**APPEAL UNDER SECTION 47(2) OF THE TOWN AND COUNTRY PLANNING (SCOTLAND) ACT
1997 BY DART ENERGY (FORTH VALLEY) LTD CONCERNING COAL BED METHANE
PRODUCTION, INCLUDING DRILLING, WELL SITE ESTABLISHMENT AT 14 LOCATIONS AND
ASSOCIATED INFRASTRUCTURE AT LETHAM MOSS, FALKIRK, AND POWDRAKE ROAD,
NEAR AIRTH, PLEAN**

(REFERENCES PPA-240-2032 AND PPA-390-2029)

PRECOGNITION BY PROFESSOR DAVID K. SMYTHE

CONCERNED COMMUNITIES OF FALKIRK

Fig. 2. PEDL133 (green dashed area) and location of two geological cross-sections shown in orange; AA' (E-W) and BB' (N-S). Blue shapes show the PDA as in Figure 1.

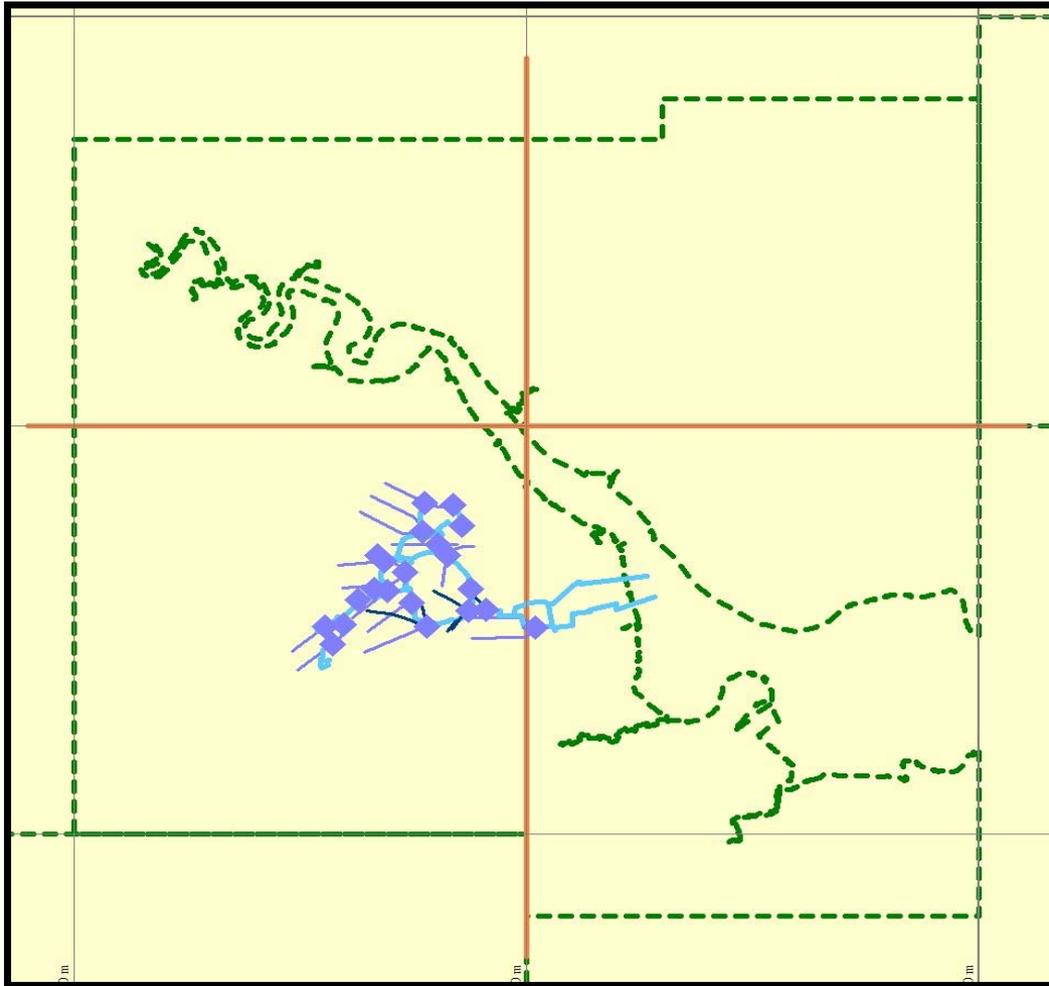
2.3.10 The two cross-sections supplied by Dart are of very limited use, due to their inappropriate location relative to the PDA, as mentioned above. Figure 2 illustrates this.

2.3.11 Section BB' passes 2.3 km east of Airth-6, and a geological column of the well is featured at the side. A much more useful section would have been one running directly through both Airth-6 and Inch of Ferryton-1. Construction of such a cross-section is not difficult; it could be carried out correctly by an Honours undergraduate student in geology, and would take only a couple of hours. I see no rational reason why this has not been carried out by Dart.

Fig. 4. Southern half of cross-section BB', as revised by Dart, October 2013, south on left. The locations of six faults (vertical red arrows) have been superimposed from the BGS maps. These should have been shown on the cross-section.

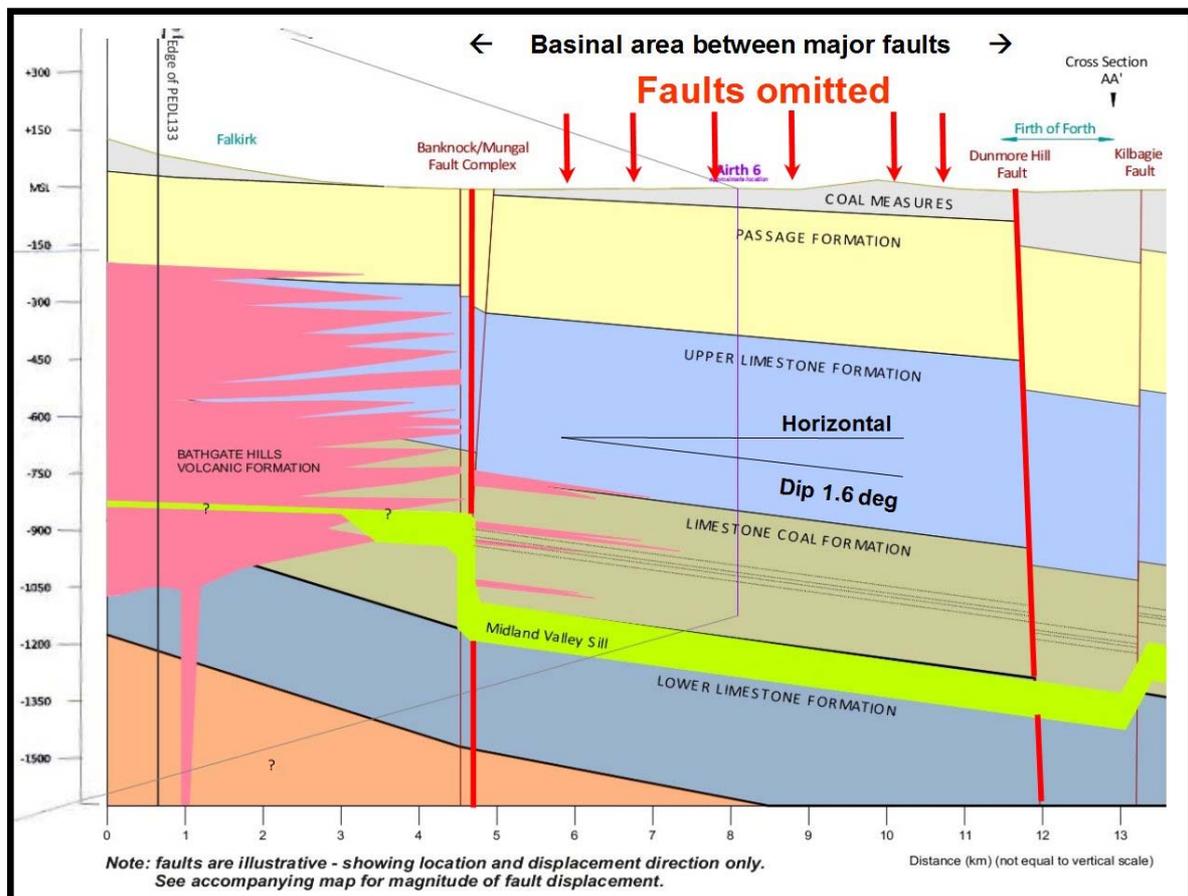
2.4.2 Section BB' (G20, Appendix 2) is misleading, as it excludes several of these normal faults, trending east-west, within the PDA (Fig. 4). Two of these have throws of 34 m and 50 m, respectively, at the location of the cross-section. The latter fault lies at the southern margin of the PDA at the section location, and runs westwards right through the PDA. Another E-W fault about 1 km south of the PDA has a throw of 40 m.

2.4.3 Dart had the opportunity to revise the cross-sections AA' and BB' presented in the original G20 submission, but has not done so. Section BB' is of particular concern, as it runs through the eastern part of the PDA. According to Dart, the central portion of the cross-section shows geological layers between two large faults, The Banknock-Mungall Fault complex to the south and the Dunmore Hill Fault to the north (Fig. 4). Between these, the layers simply dip (slope) constantly northwards at about 1.6°, according to Dart. I have marked this on Figure 4 by means of a wedge. The revision of section BB', instead of correcting the geology, has comprised merely the removal of the vertical scale on the left, and has added the following text:

“Note: faults are illustrative - showing location and displacement direction only. Distance (km) (not equal to vertical scale). See accompanying map for magnitude of fault displacement” [see Fig. 4].

2.4.4 In Figure 4 I have restored the missing vertical scale, and adjusted the horizontal and vertical scales anamorphically so that the vertical exaggeration is 5: 1. The *“accompanying map”* in the Appendix does not illustrate the magnitude of fault development, as claimed by the new caption. It would appear that the text has been added as a disclaimer, because Dart was aware that the cross-section was erroneous. In my view this is an unacceptable shortcut to avoid a rational and accurate re-drawing of the geology. All these faults are significant for consideration of the danger of fugitive methane emission and contamination of groundwater resources, and should not have been omitted from the proposals. Much more detailed work is required.

Fig. 6. Schematic re-interpretation of the central part of Dart cross-section BB'. The oversimplified Dart structure of a constant northward dip of about 1.6° has been replaced by a more accurate depiction of the structure of the base of the Coal Measures.

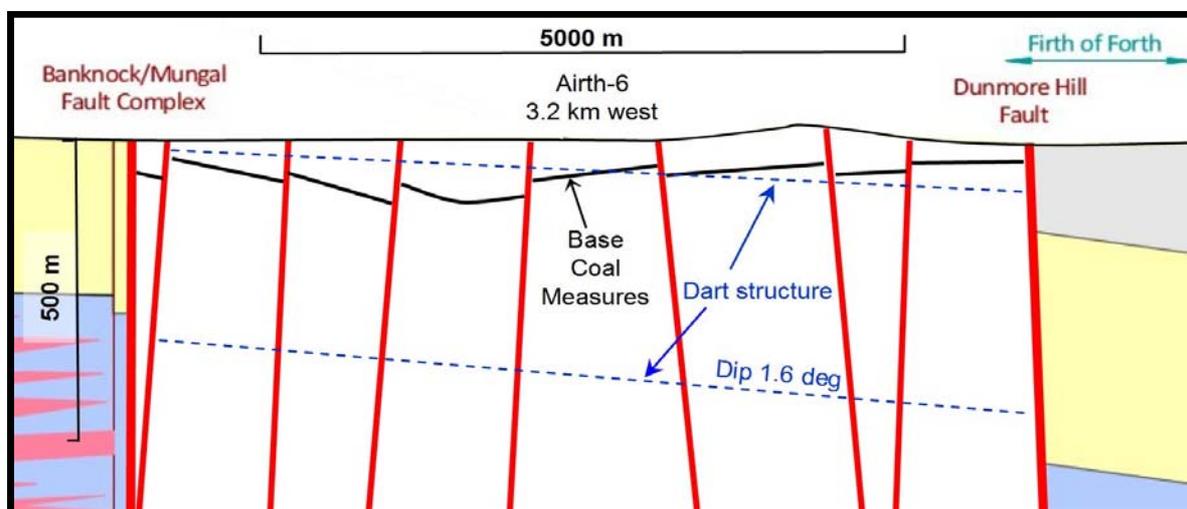
2.4.6 I have schematically re-interpreted the central part of Dart's cross-section BB' to show what the geology should look like. This is shown in Figure 6. The base of the Coal Measures is shown by the black lines between the various faults; this replaces the over-simplified constant-slope line depicted by Dart (the upper blue dashed line in Figure 6). The same principle will apply to all the geological layers below, including down to the target coals at 900 m or so below sea level, but I have not attempted to show all these.

Fig. 7. Dart geological structure map of the Lower Bannockburn Main Coal horizon, showing the Carbrook and Kinnaird House Faults as two separate structures. Faults at the coal horizon are shown as solid black lines, and at the surface as dashed blue lines.

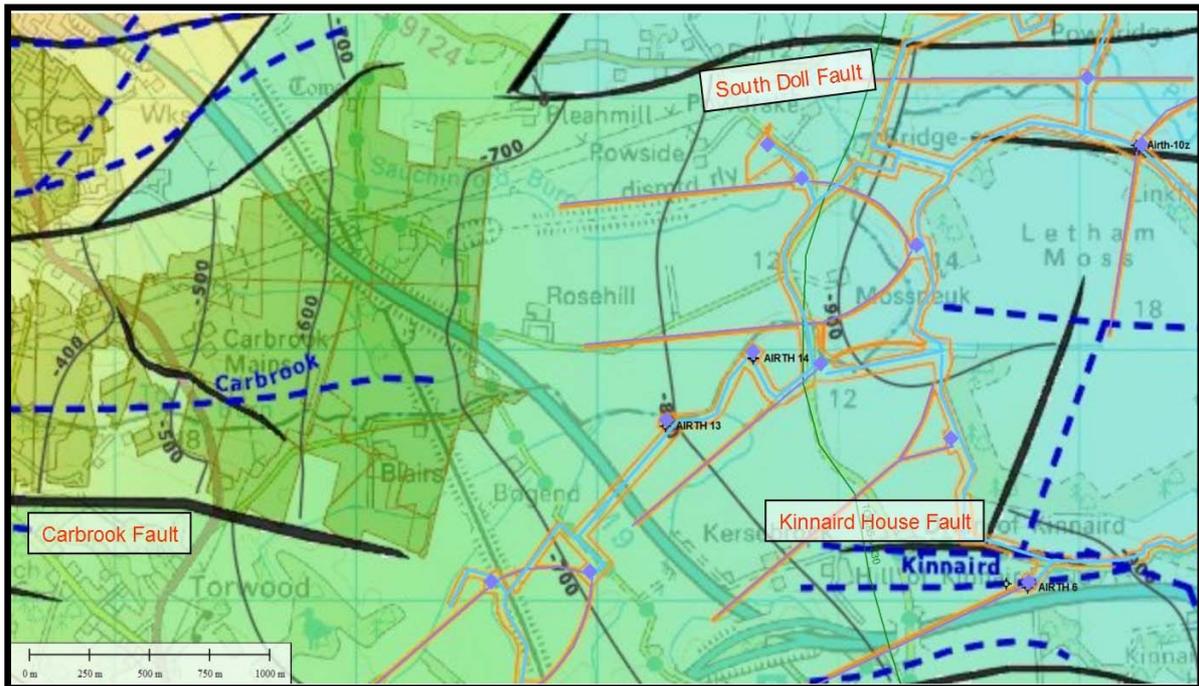
2.4.8 Dart's subsurface drilling plans depend heavily on its geological interpretation. Here I show that the latter is severely flawed. Figure 7 shows a detail of the geological structure map produced by Dart for the Lower Bannockburn Main Coal horizon, one of the target coals. Faults are shown cutting this layer as solid black lines; the same fault at the Earth's surface is shown by blue dashed lines. The two sets of lines are in general not at the same position because the fault surface is not vertical. For example, the surface position of the Carbrook Fault is about 500 m north of where it cuts the coal layer; this shows that the fault surface dips (slopes) to the south. The problem with Dart's interpretation is that it shows the Carbrook and the Kinnaird House Faults as separate structures, so that there is an unfaulted area of about 4 km² just west of Letham Moss, in the heart of the PDA.

2.4.9 But Dart's interpretation is contradicted both by the BGS geological maps and by the available 2D seismic lines. Figure 8 shows the BGS-mapped faults in red. The Carbrook – Kinnaird House Fault is continuous as a single major structure across the area. The throw of the fault (vertical displacement) is marked in red, from which we can see that the expected throw in the vicinity of Airth-13 and Airth-14 is about 100 m. But Dart's map of the coal layer shown in Figure 7 has no (geological) faults at this locality.

2.8.5 Furthermore, if the Dart geological structure map of the Lower Bannockburn Main Coal horizon (see Figure 7 above) is to be believed, the whole PDA comprises just two compartments; (1) the northern area north of the Aith Church Fault and east of the Dunmore Farm Fault (see Figure 14 for the latter), and (2) the rest of the PDA. However, I accept neither the evidence for fault sealing and compartmentalisation in the PDA zone, nor the details of Dart's mapping of the faults.

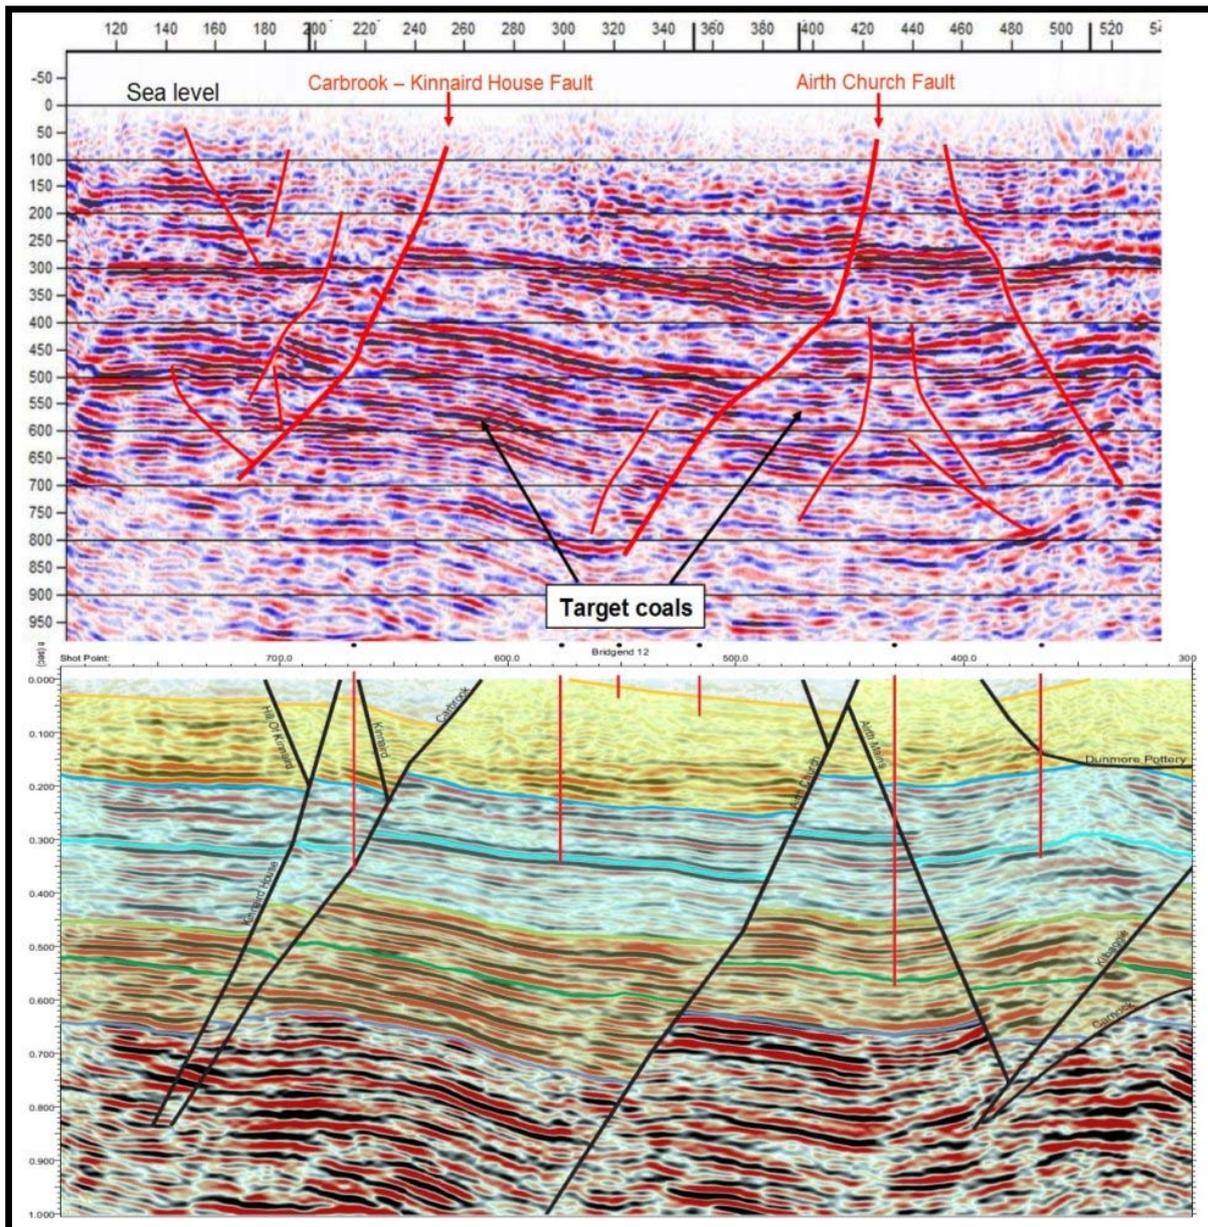
2.4.12 Figure 9 shows two versions of seismic line TOC85-V330, crossing the PDA from south to north, both at the same horizontal and vertical scales. The upper panel shows the raw migrated data over the PDA, to which I have added an interpretation of faults, as shown in red. The surface locations of the Carbrook – Kinnaird House Fault, and another E-W fault which Dart calls the Airth Church Fault, are shown above the section, marked by red arrows. These clearly correlate with the major faults seen on the seismic data.

2.4.13 The upper panel fault interpretation was drawn up before I had access to Dart's own interpretation, which is shown at the same horizontal and vertical scales in the lower panel of Figure 9. Dart's seismic image is based on data which has been reprocessed, relative to the UKOGL data (Fig. 9, upper panel). This does not necessarily imply that it is of better quality. However, there is evidently substantial agreement between the two versions, although there are minor differences in the shape and curvature of the faults. My guesstimate (without access to well logs and detailed interpretation software for the purpose) of where the coal horizons would plot on the seismic data (Fig. 9, upper panel) is only in error by around 50 milliseconds (ms). The coal horizons are indicated by the green line on Dart's interpretation.

2.4.14 The vertical scale of the seismic data is measured in milliseconds of reflection time, not in metres. To convert this to depth we would need some sort of velocity or sonic log data, but these do not seem to be available. No sonic log was run for Airth-6 (Dart G20 revised submission, Appendix 3). We have no details of how Dart has converted the vertical scale of the seismic data from time to depth.

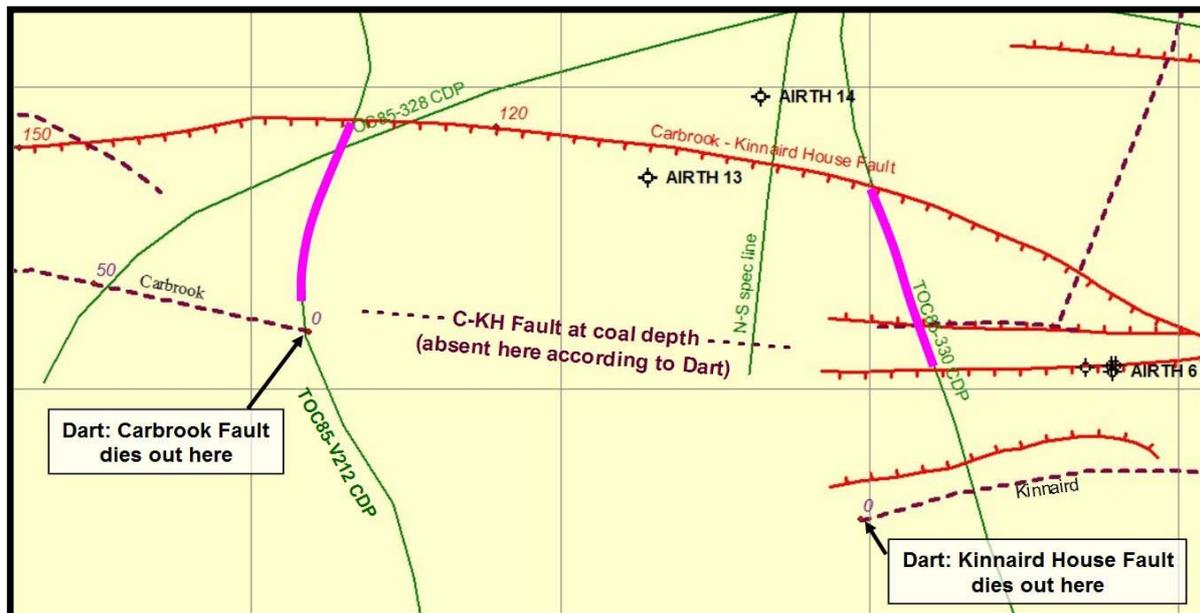
2.4.15 The problems with Dart's interpretation start when we go west from line TOC85-V330 discussed above. Relevant data are shown on the map of Figure 10. The map shows that there is a N-S seismic line 200-500 m west of line TOC85-V330, which must belong to a speculative survey, as it has not been released by DECC even though it was obtained in 1982. I therefore do not have access to it. However, as its termination is 700 m south of the surface position of the Carbrook – Kinnaird House Fault, it is unlikely that it can contribute much to the problem in hand; this is because the starting and ending kilometre or more of seismic lines have reduced quality data compared to the middle sections.

2.4.16 On the right-hand side of Figure 10 the Carbrook – Kinnaird House Fault cuts the coal horizons on line TOC85-V330 where the purple dashed line has been interpreted by Dart. According to Dart this Kinnaird Fault dies out 400 m to the WSW, where the number 0 marks the throw (displacement) of the fault (0 m at its tip; throws elsewhere are indicated from the BGS mapping in red or the Dart interpretation in purple).

2.4.17 Moving eastwards from the western edge of Figure 10 we see that Dart has mapped a separate 'Carbrook' Fault dying out just at the intersection at depth with seismic line TOC85-V212. So according to Dart there is a zone about 1.5 km wide where the Carbrook – Kinnaird House Fault does not exist. But this interpretation conflicts with the BGS map of the major fault, which shows a throw of 120 m at the surface in the upper-central portion of Figure 10.

Fig. 11. N-S seismic line TOC85-V212, with my fault interpretation shown as red lines. The Carbrook – Kinnaird House Fault is clear at depth, dipping to the south from its mapped surface location. The footwall of the fault (below it, on the north side) is disturbed by other faults.

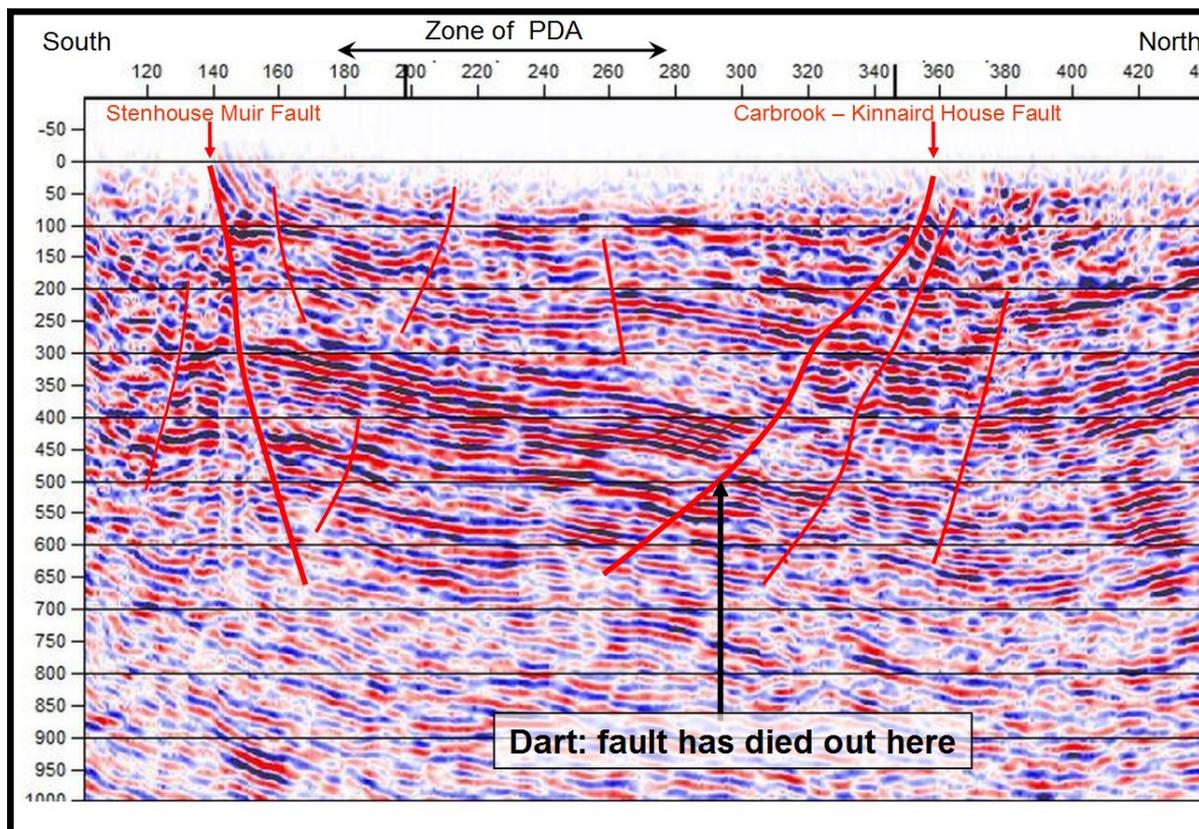
2.4.18 North-south seismic line TOC85-V212 (located in Figure 10) is shown in Figure 11. The image is taken from the UKOGL database. As with the upper part of Figure 9, I have added an interpretation of the faults, shown as red lines. The Carbrook – Kinnaird House Fault is present as an important fault, along with several others. But according to Dart it should not exist on this image because the fault has died out going eastwards. Therefore if Dart is correct the layers shown in this image should run continuously across the right-hand side of this image without displacement. This is clearly erroneous.

2.4.19 I conclude that Dart's interpretation of the geology in this part of the PDA is seriously in error. The error occurs in the middle of the PDA, where there is a 1.5 km data gap with no seismic lines, nor drill holes. The simpler interpretation, which is consistent both with the BGS surface fault mapping and with the seismic data, is that there is a single major fault, the Carbrook – Kinnaird House Fault, running right through the area. Dart's error has probably arisen from allowing an automated gridding and contouring computer program to construct the depth map for the Lower Bannerman Main Coal (Figure 7 above). A better method would have been to have used hand contouring by an experienced geologist, who could have taken into account both the serious data gap and the prior knowledge of the BGS surface geology maps.

Fig. 12. Horizontal wells Airth-8y and Airth-6z drilled by Composite Energy. Dashed dark blue lines show the planned trajectories; solid dark blue lines are the actual trajectories. Mid-blue lines are proposed Dart horizontals. The circle highlights where horizontals will cross one another.

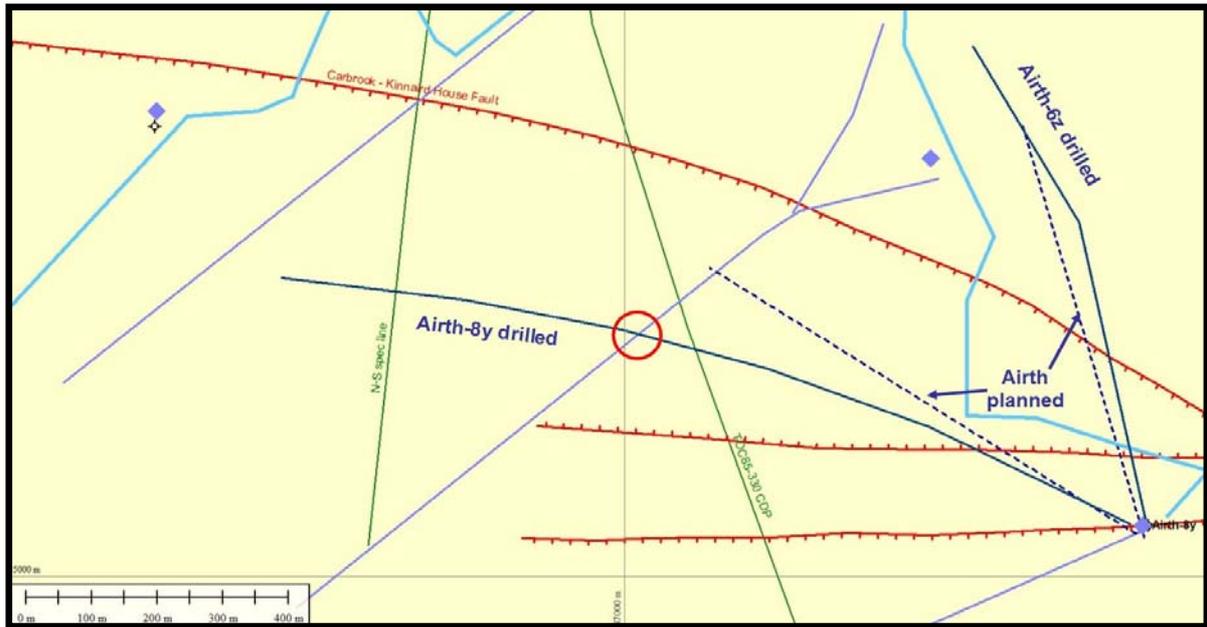
2.4.20 There is an additional anomaly in the area of the Carbrook – Kinnaird House Fault, revealed by the existing sidetracked wells. Details are shown in Figure 12. Planning application documents show that the sidetracked wells were intended to be drilled in a NNW and NW directions from Airth-6 and Airth-8, respectively. The planned tracks are shown as dark blue dashed lines in Figure 10. But the Airth-6z horizontal was drilled with a dogleg. We need to understand why. The actual trajectory of Airth-8y is more curious; this is the solid dark blue track shown in Figure 12. Why did it diverge, increasing into a more westerly azimuth, away from the vertical hole? According to the current Dart interpretation this Airth-8y horizontal should be in the footwall of the Carbrook – Kinnaird House Fault. If it was in fact in the hanging wall of the fault, the drill bit, guided by gamma-ray logging, may have been repeatedly grazing it on its right-hand (north) side, and was therefore steered in a progressively more westerly direction as drilling proceeded. On the other hand, if the sidetrack was deviated into the hanging wall, why was the drill bit steered in a direction locally parallel to the Fault just below it? Whatever the correct explanation, we need to know why the sidetracked well took this path.

2.4.21 If and when Dart drill horizontally to the SW (mid-blue lines shown in Figure 12), the proposed well track at each coal horizon will cross the old Composite Energy sidetrack of Airth-8y. This intersection is highlighted by the red circle in Figure 12. How will Dart deal with this intersection? It would appear to provide scope for uncontrolled leaks of drilling or dewatering fluid and methane.
